Questions to
Study on sound level limits of M-and N-
category vehicles
on TFVS-09-06 and TFVS-07-11

10th TFVS meeting
12. July 2022

JAPAN AUTOMOBILE STANDARDS INTERNATIONALIZATION CENTER

Fig26 @TFVS-09-20 Fig72 @TFVS-07-11

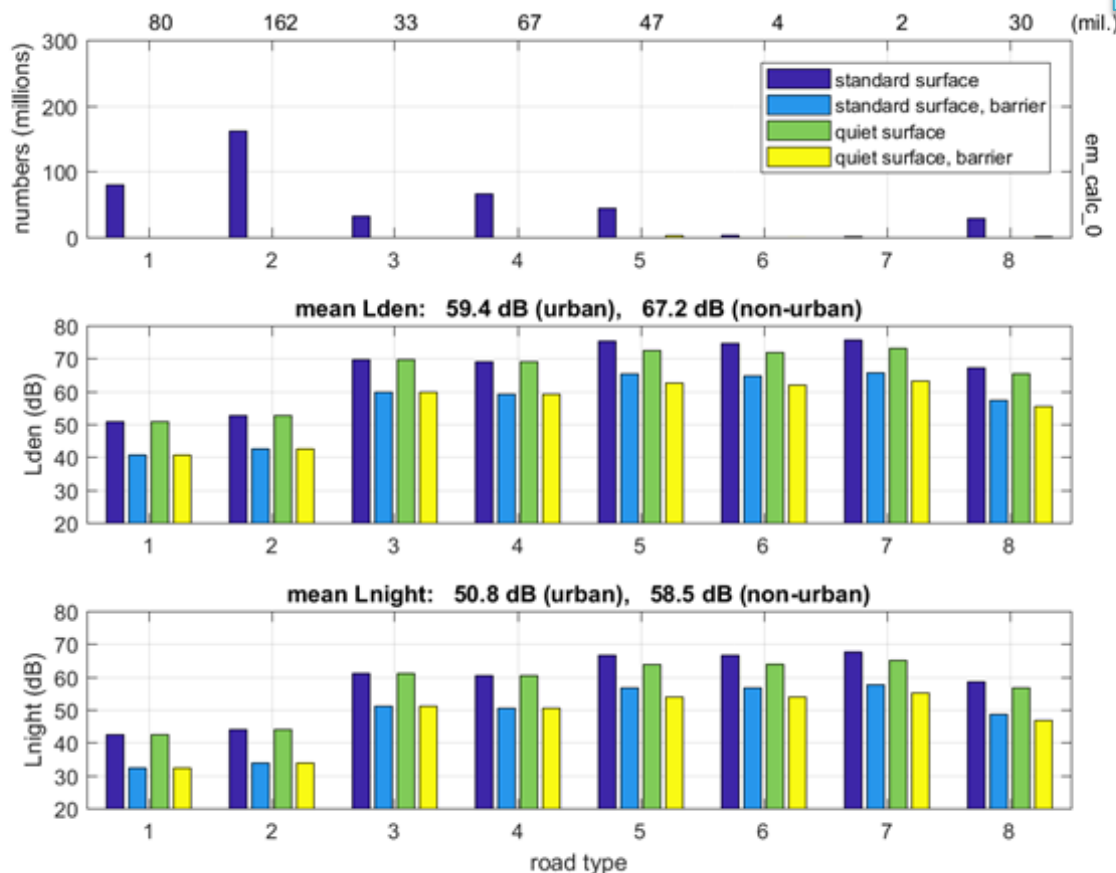
Question;
 What is the standard road surface?
 What is the quiet road surface?

Information;
 COMMISSION DIRECTIVE
 (EU) 2015/996
 — a virtual reference road surface, consisting of an average of dense asphalt concrete 0/11 and stone mastic asphalt 0/11, between 2 and 7 years old and in a representative maintenance condition

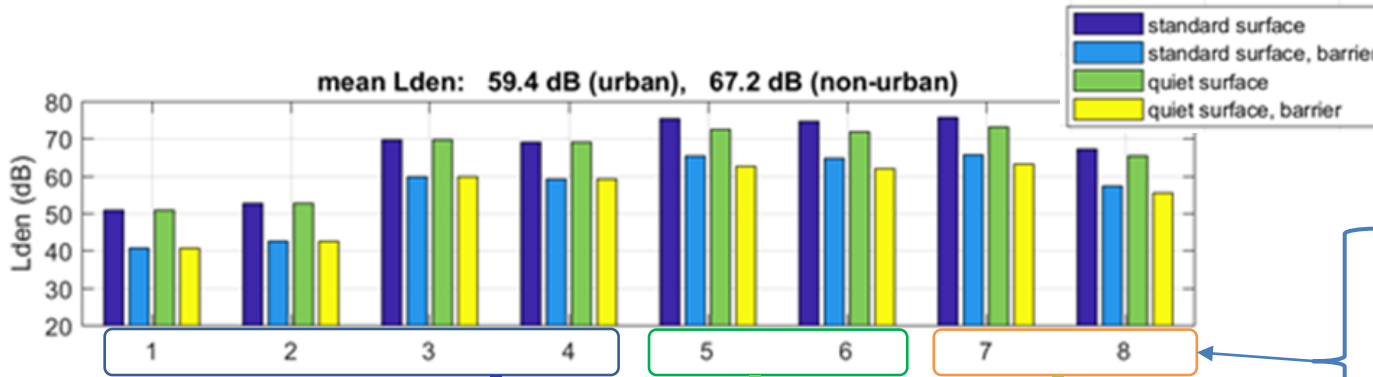
Confirmation;
 The road surfaces at road type 1 to 4 are kept standard surface, but not quiet surface.
 The Correction coefficient of road surface (Table 46 @TFVS-07-11) are original and different from CNOSSO-EU.

Fig26 @TFVS-09-20 Fig72 @TFVS-07-11

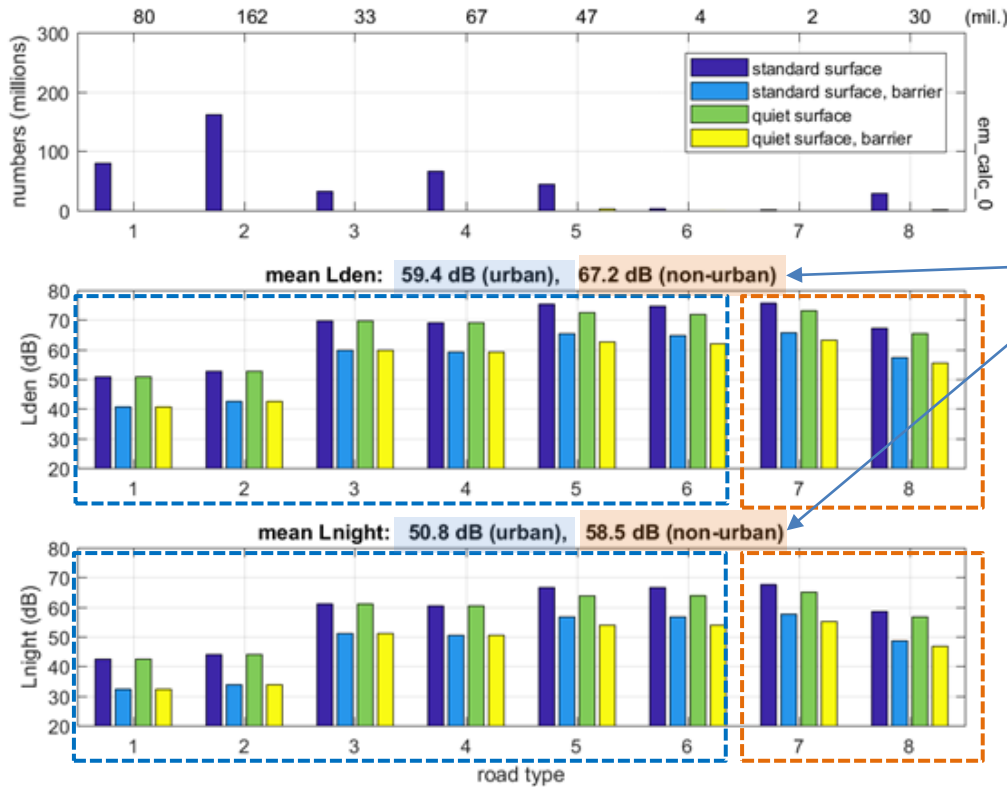
Question;
How to calculate the mean value of Lden and Lnight with different road types?
